San Francisco Bay Regional Water Quality Control Board

DATE: October 21, 2016

**SUBJECT: RESPONSE TO SANTA CLARA VALLEY WATER DISTRICT COMMENTS ON
THE UPPER BERRYESSA CREEK FLOOD PROTECTION PROJECT
TENTATIVE ORDER**

Figure 1. Longitudinal Profile Comparison of primarily the “Greenbelt Reach” (Crosley Creek Culvert to Old Piedmont Road) in 1967, 1987, and 2004.

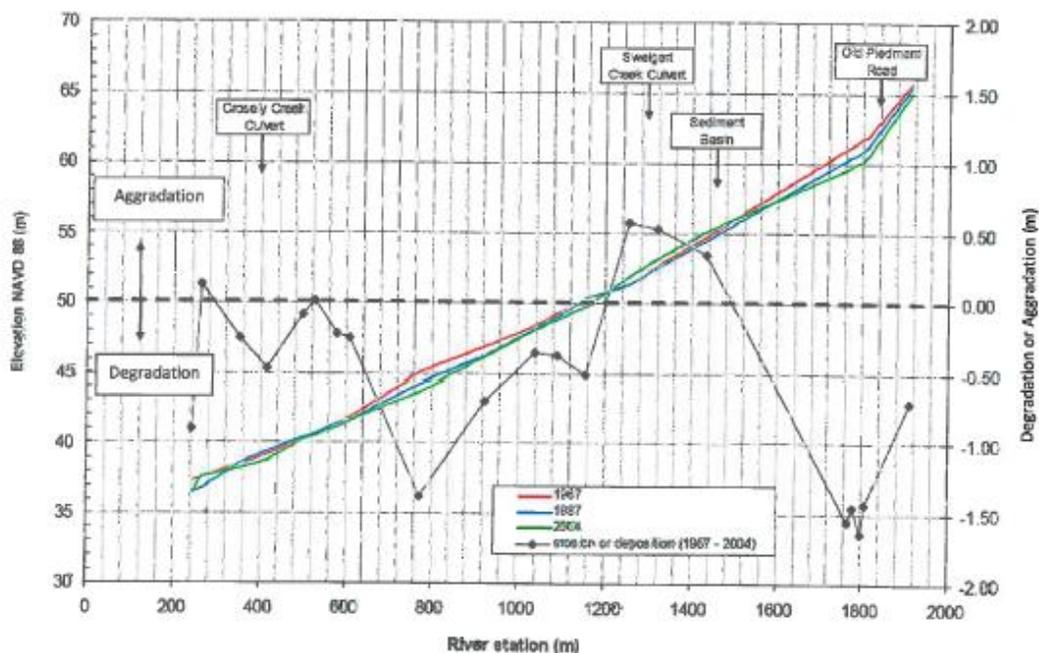
The District's technical memorandum of July 20, 2016, includes a graphic showing the longitudinal profile comparison from 1967 and 2004 (see below) and interprets this graphic as evidence of incision. This graphic's spatial extent is from Old Piedmont Road to the Crosley Creek culvert, which is primarily the section of the creek known as the "Greenbelt Reach." This graphic shows the channel upstream of the Project reach and does not include the proposed Project reach.

We do not have adequate information to interpret this graphic. We do not know how many points were collected along each profile and whether the perceived differences are merely a function of line interpolation or an actual difference in elevation between surveyed points (assuming both surveys have the same datum and were performed with comparable care and quality). Without knowing anything about the quality of the surveys, one could also interpret this graphic as showing a sediment wave that passed through the upstream part of the reach with incision along the downstream part (again, assuming these lines do actually have enough data points). The upstream, downstream, and middle of the reach (around station 1,200 in Figure 1) have stable elevations. A sediment wave that deposited in the upstream of this reach in 1967 may have spread downstream by 1987. There appears to be another depositional site around station 800; however, because the 400 meter long reach downstream of it stayed at the same elevation for almost 50 years suggests that the reach does not have an incisional trend, rather that the sediment wave likely passed and spread downstream. We would expect to see large sediment pulses that temporarily deposited in this upstream reach considering the large storms of 1962, 1963, and 1967.³ Without providing any other context and evidence for incision, this graphic is not evidence for incision upstream of the project reach.

Finally, even with all the uncertainty, if this graphic is considered as evidence of incisional trends upstream of the Project reach this would suggest that there has been a significant amount of sediment scoured from the creek bed upstream of the Project reach and delivered to the Project reach in the last 40 years, invalidating the District's suggestion that sediment along the project reach is locally sourced.
